Our Ref: PSM3739-021L Rev 1

**RE: MIRVAC ASPECT INDUSTRIAL ESTATE -
788-904 MAMRE ROAD, KEMPS CREEK
SALINITY MANAGEMENT PLAN**

Our Ref: PSM3739-023L

**RE: MIRVAC ASPECT INDUSTRIAL ESTATE -
PSM RESPONSE TO E2D QUERIES**

Inset 2: Cross Section to compare the elevation of the Site to the elevation of Kemps Creek

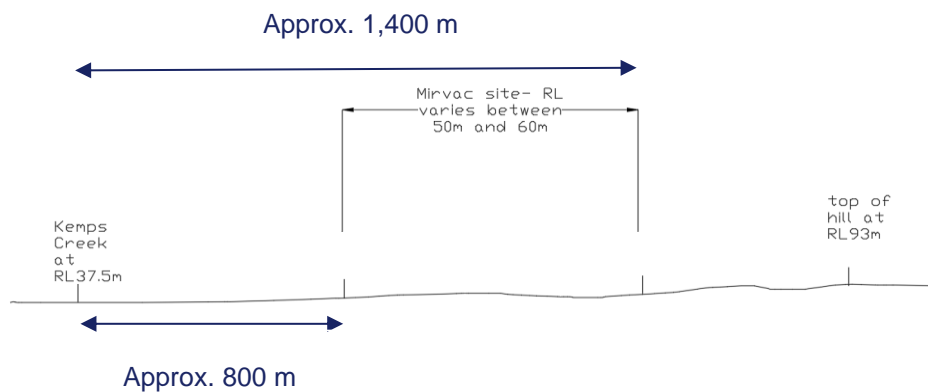
2.6 Comment on the regional groundwater flow characteristics of the broader Mamre Road Precinct

PSM response: The Site is located at the east of Kemps Creek. Based on the surface elevation (from Geoscience Australia), we note that the elevation of the Site ranging between RL 50 m and 60 m is significantly higher than that of Kemps Creek at RL 30 m. Inset 1 and Inset 2 present a cross section between Kemps Creek and the Site. We did not observe groundwater in the investigation holes that we had completed.

We therefore consider the proposed development is unlikely to affect the regional groundwater.

MIRVAC AIE Review of existing Geotechnical Information

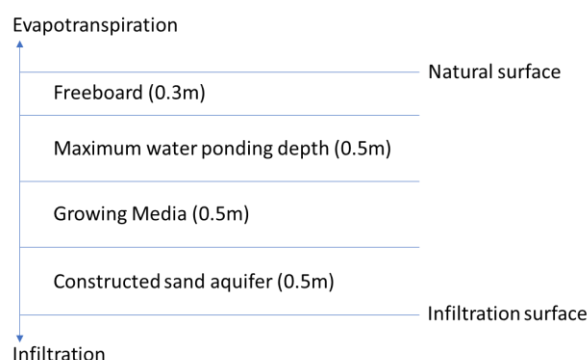
1. It appears most swamp forest (evapotranspiration/infiltration) systems will be located in areas that will remain as existing natural surface.
2. The surrounding development pads will be filled (or cut) to allow gravity drainage to the E2 corridor.
3. Swamp forest general profile.

4. Test pits 1, 3, 30, 31, 33, 34, & 35 are spatially relevant to the swamp forest locations. The infiltration surface of the swamp forest will be at least 1.8m below natural surface. Test pit logs suggest the following conditions are likely at the infiltration surface of the swamp forest:
 - Pit 1. Red clay, medium to high plasticity, becomes mottled grey and orange at 2.0m.
 - Pit 3. Orange clay, medium to high plasticity.
 - Pit 30. Orange to brown clay, medium plasticity.
 - Pit 31. Orange to brown clay, medium plasticity, becomes mottled red and grey at 0.5m.
 - Pit 33. Dark brown to black gravelly clay, low to medium plasticity.
 - Pit 34. Orange brown clay, medium plasticity.
 - Pit 35. Dark brown and black sandy clay, low to medium plasticity, becomes wet at 2.2m.
5. We note from the reports that, these soils do not appear to be saline or sodic.
